MEMORANDUM ADDENDUM #1

TO: All Bidders
FROM: David Chen
DATE: June 6, 2025
RE: Pearl River Public Library – Complete Renovation Project

Pearl River Public Library – Complete Renovation Project

ADDENDUM NO. 1

A601

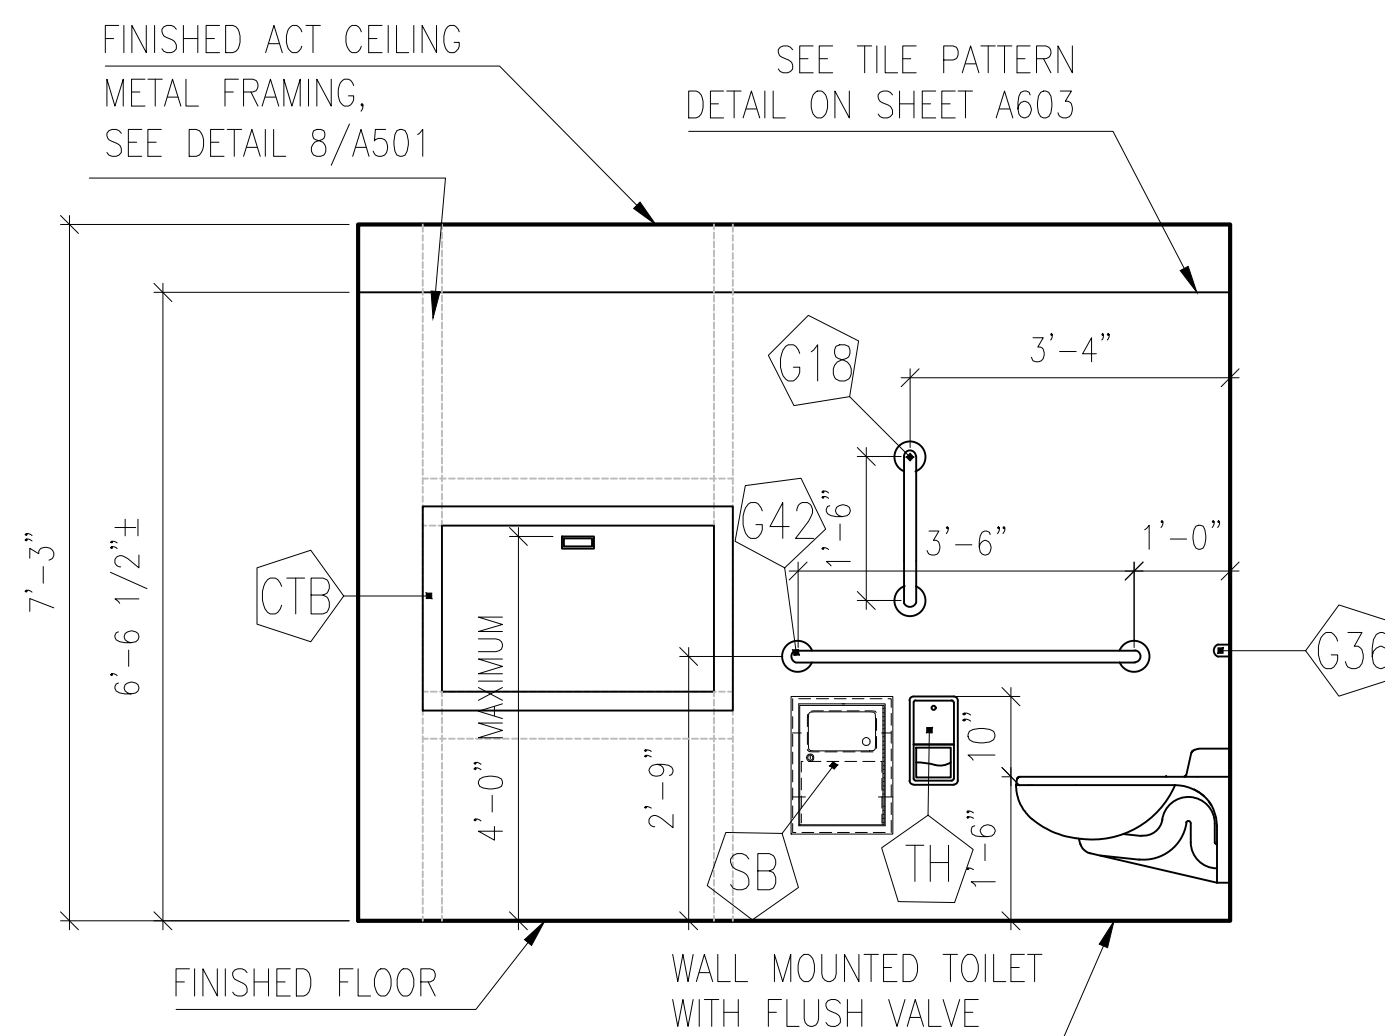
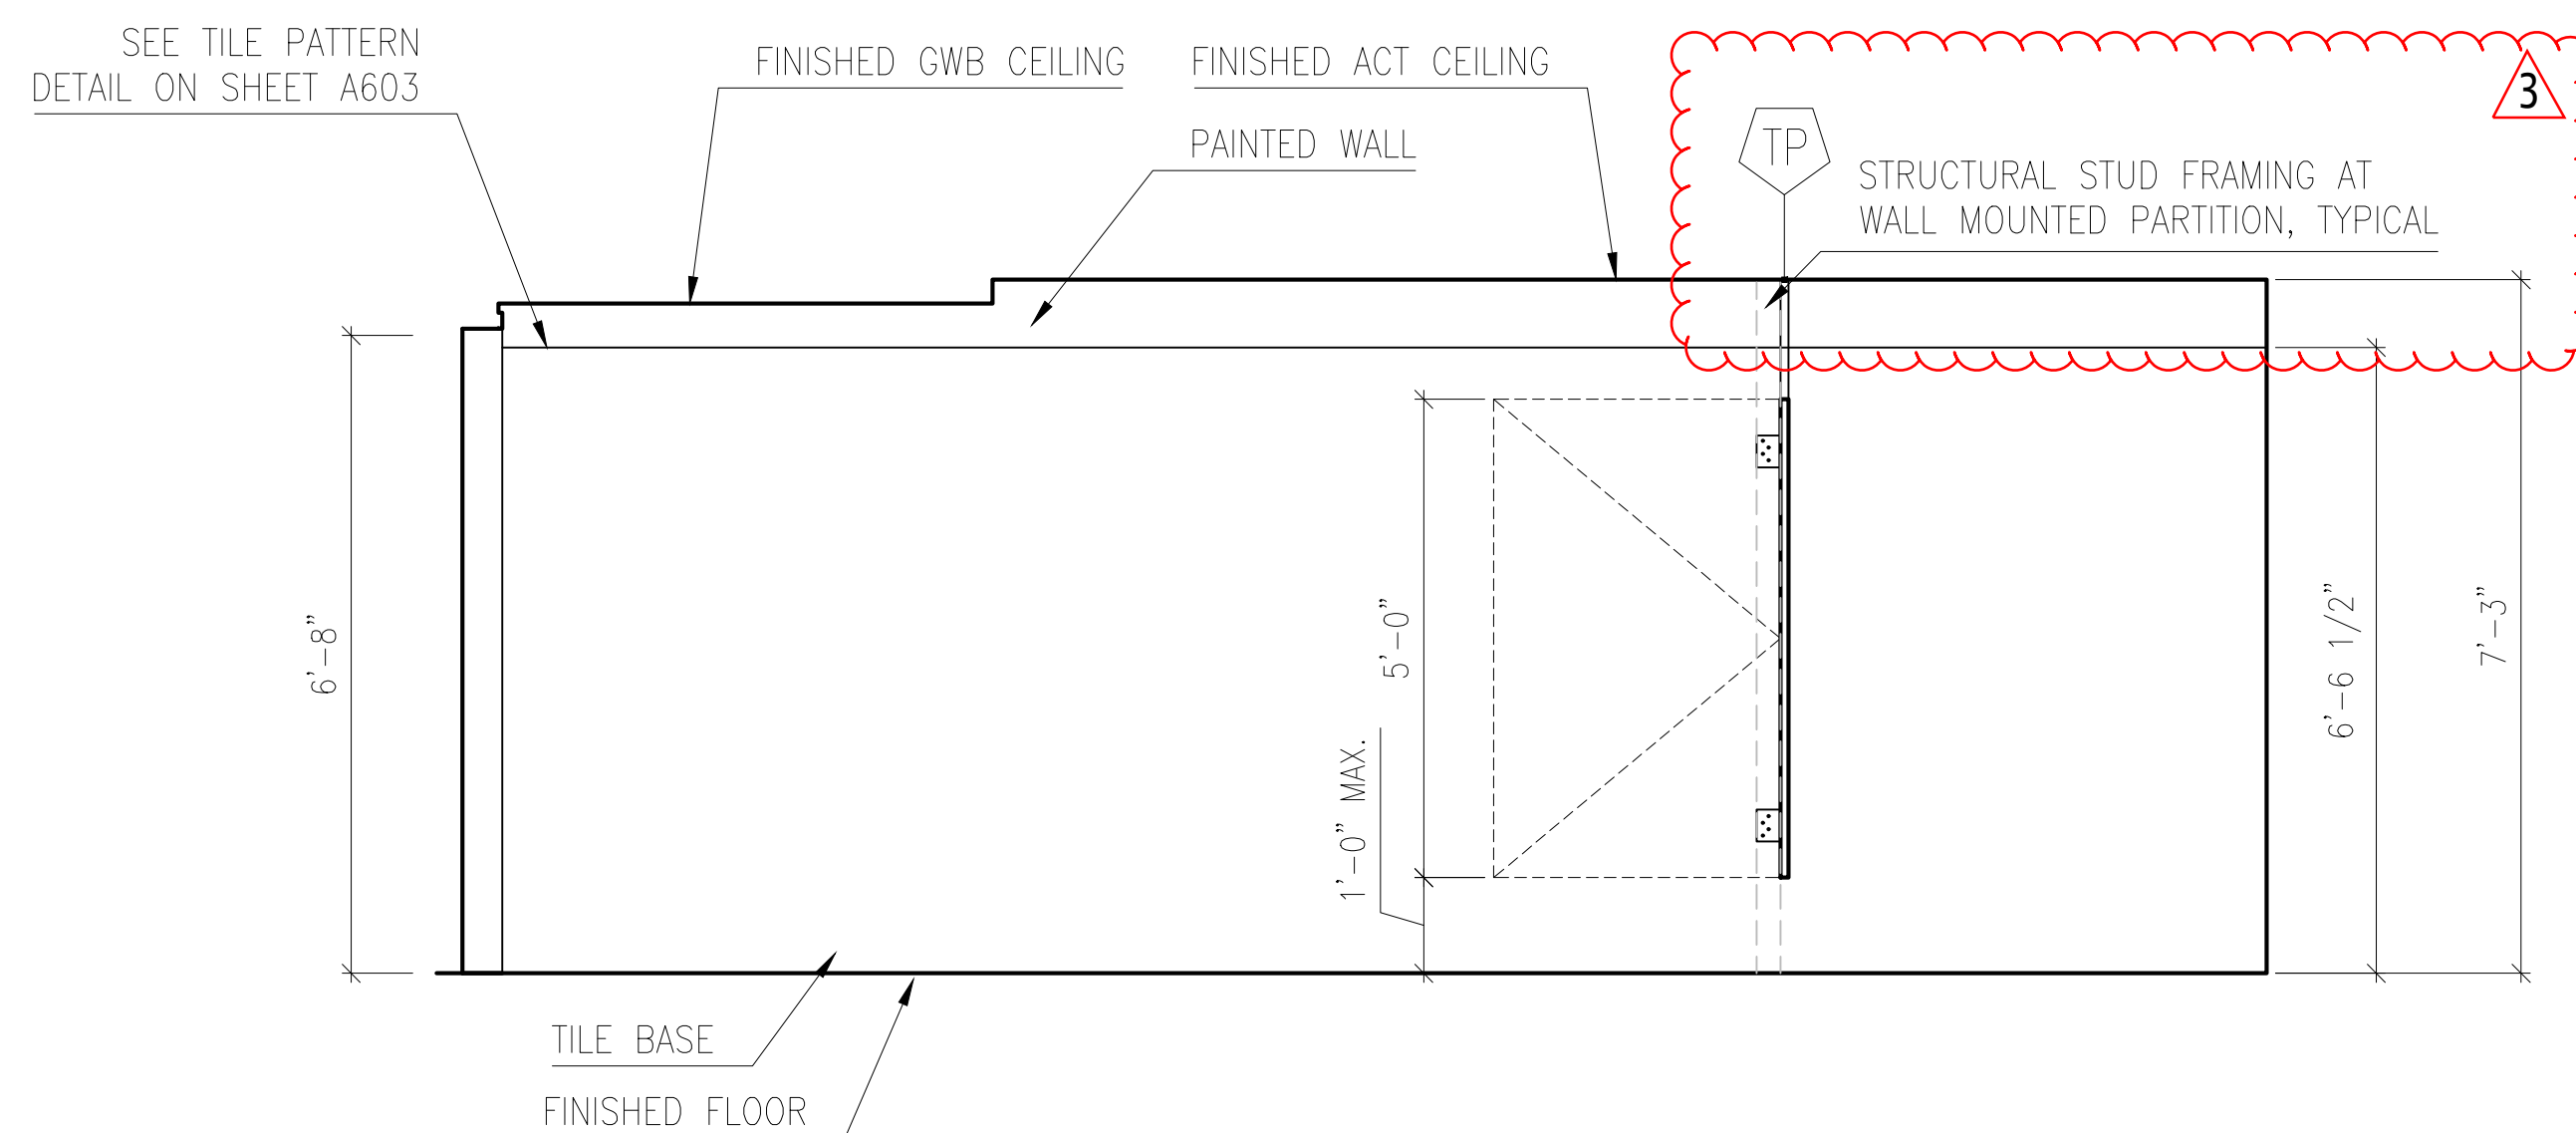
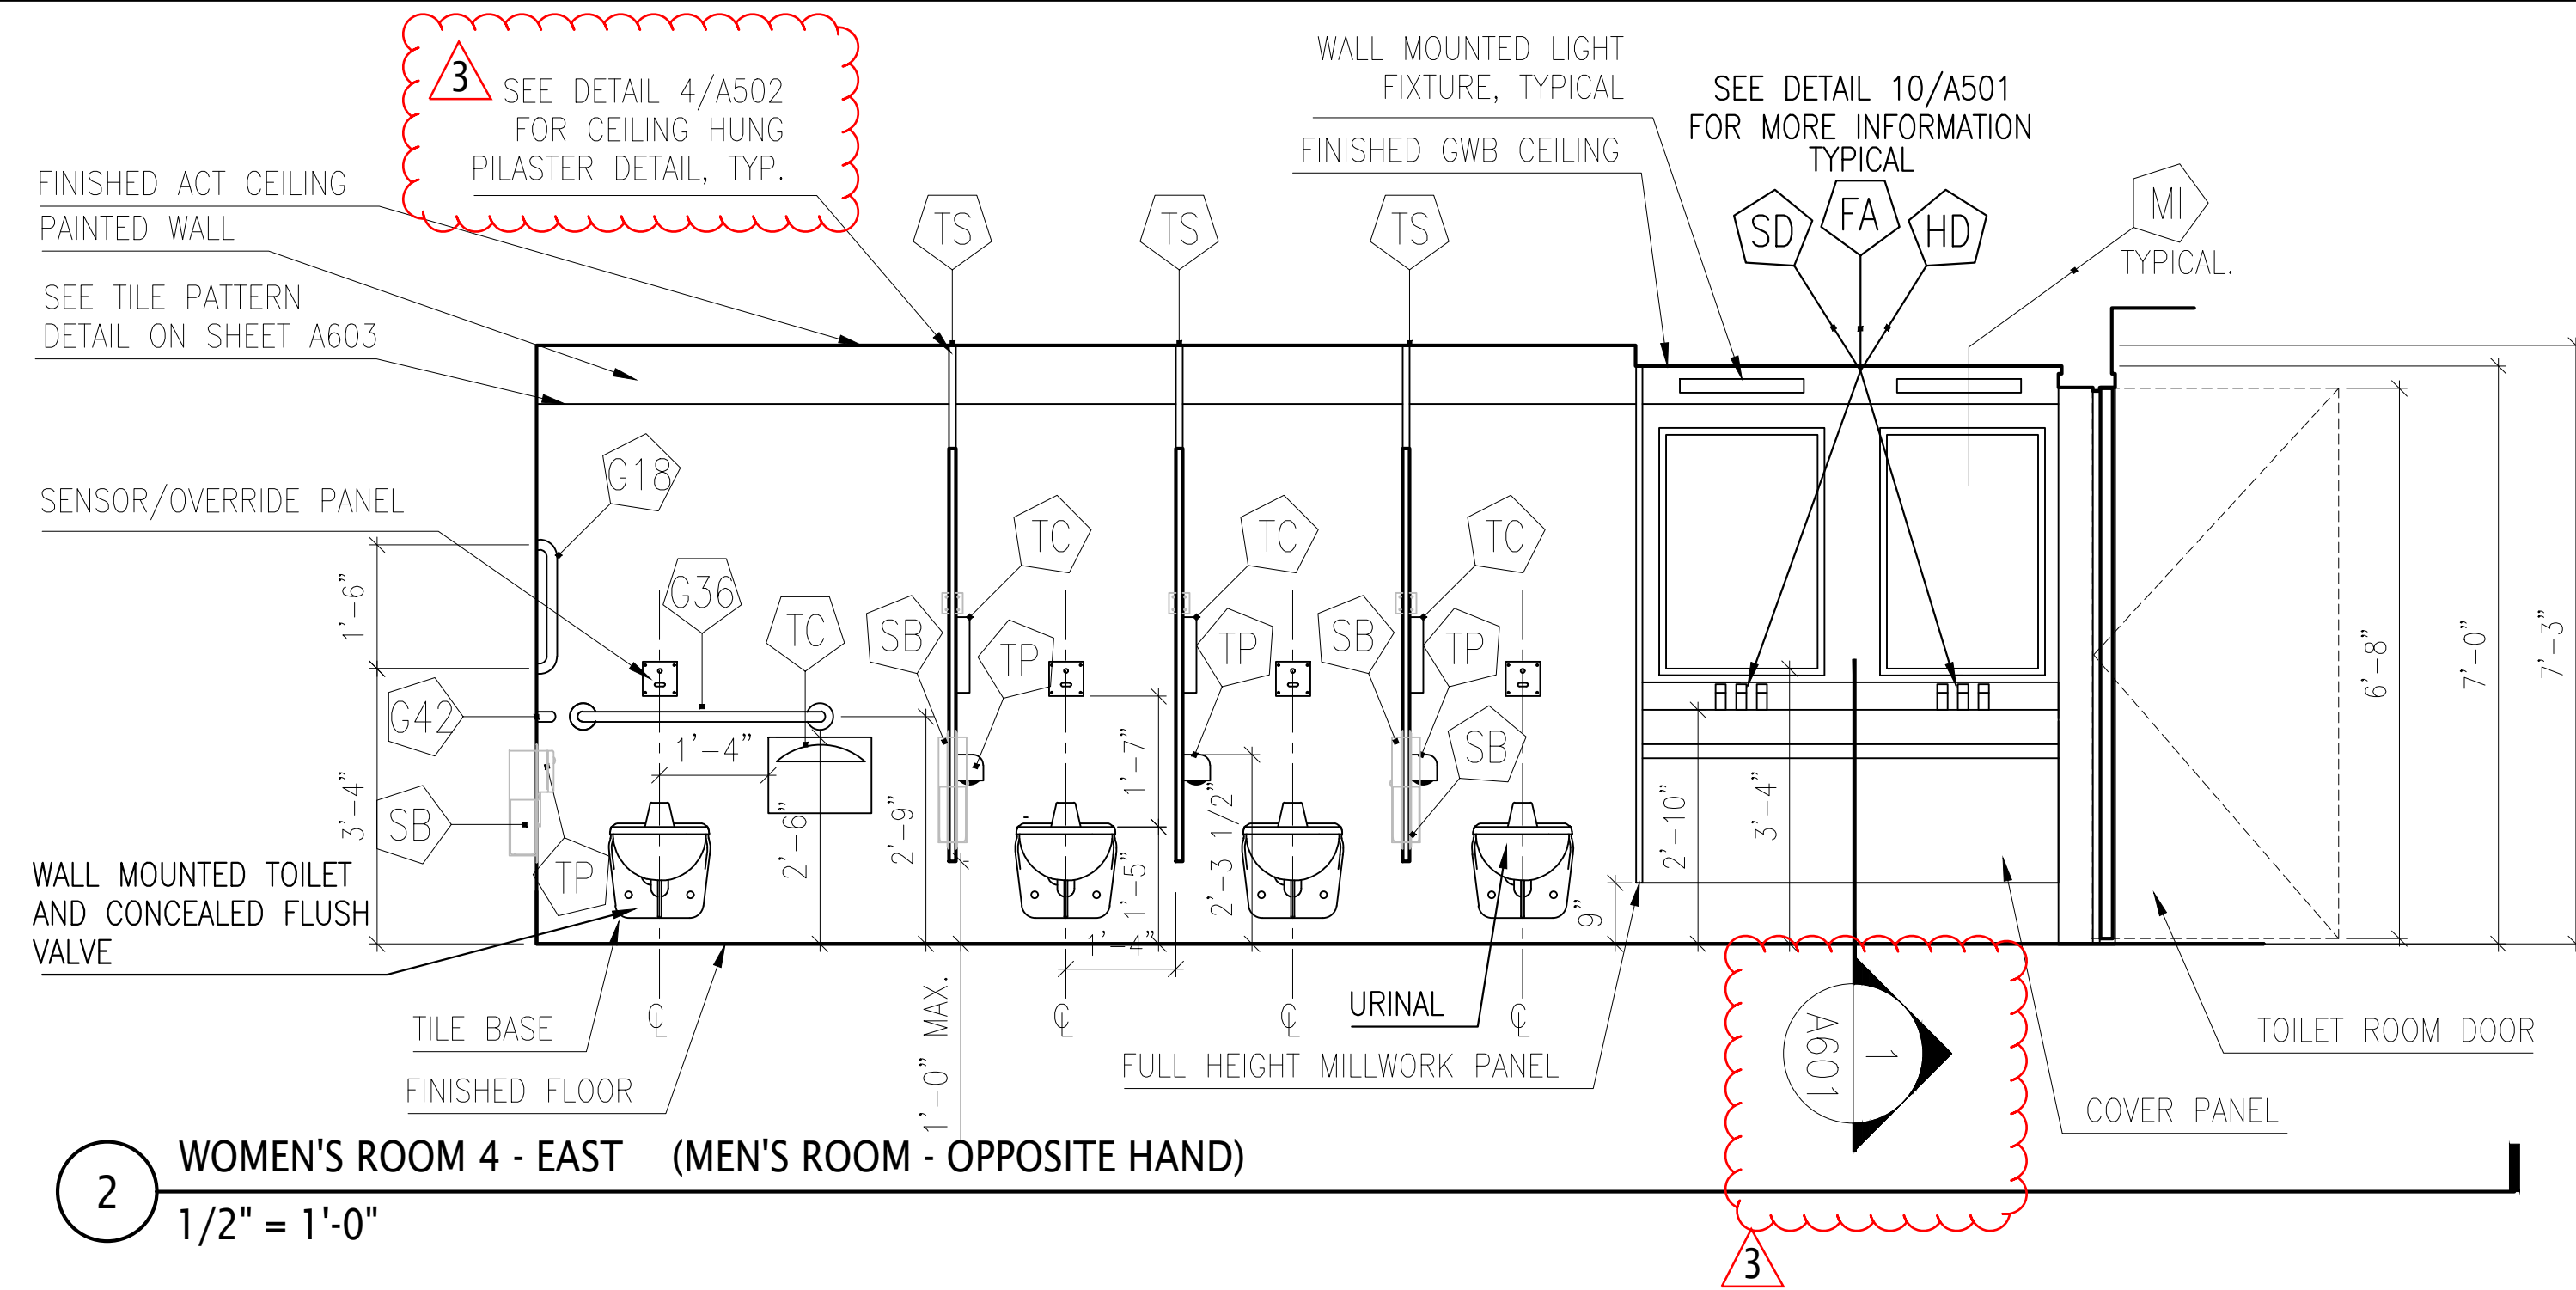
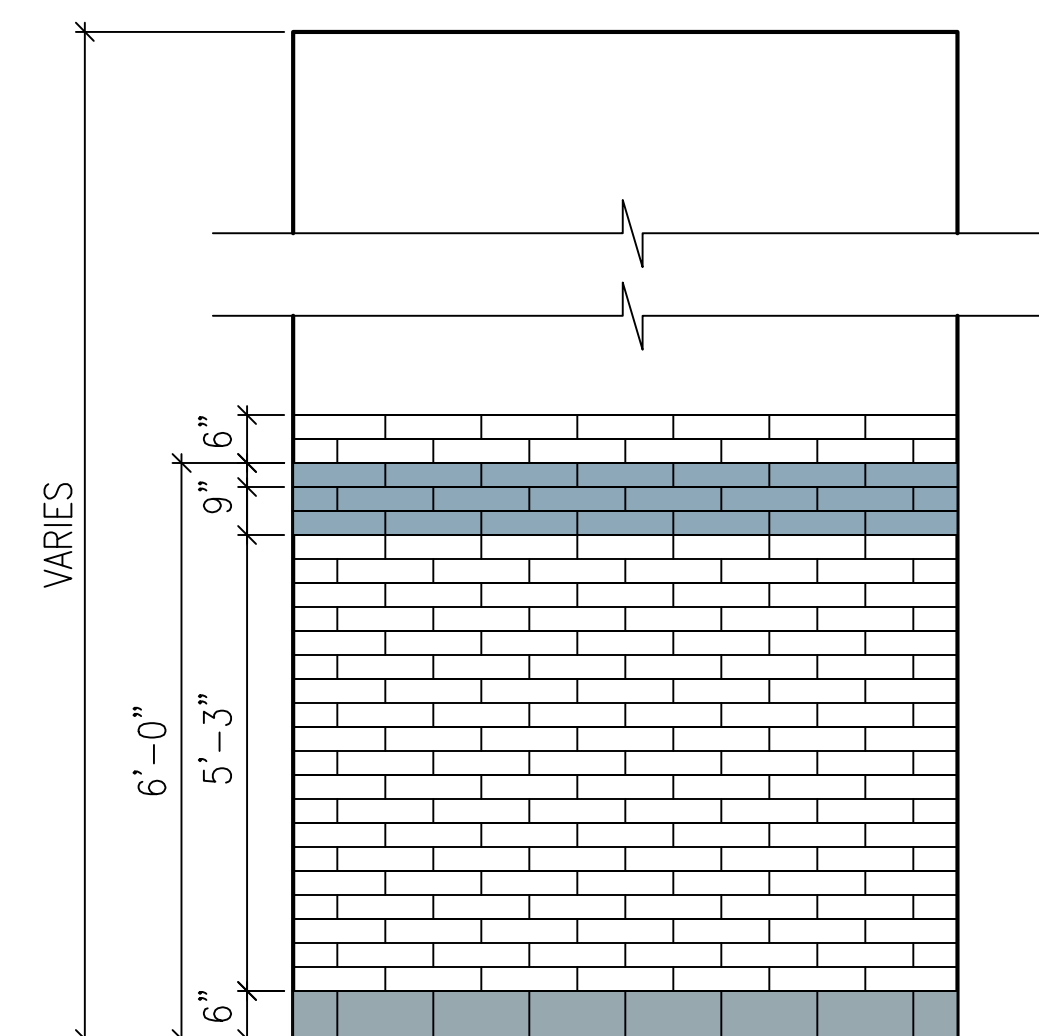
- a. **Response:** See Superseded Restroom Renovation Set “2.1 - 2578-01_23_0602 - PRPL RESTROOM BID SET AR (14p) (ADDENDUM 1)” on sheet A001.
16. **Question:** On the Restroom Renovation portion of the project on detail 1/A610 at the LAV, there is no drawing A610 to show this detail. Please advise.

- a. **Response:** See Superseded Restroom Renovation Set “2.1 - 2578-01_23_0602 - PRPL RESTROOM BID SET AR (14p) (ADDENDUM 1)” for revised detail references on sheet A601.
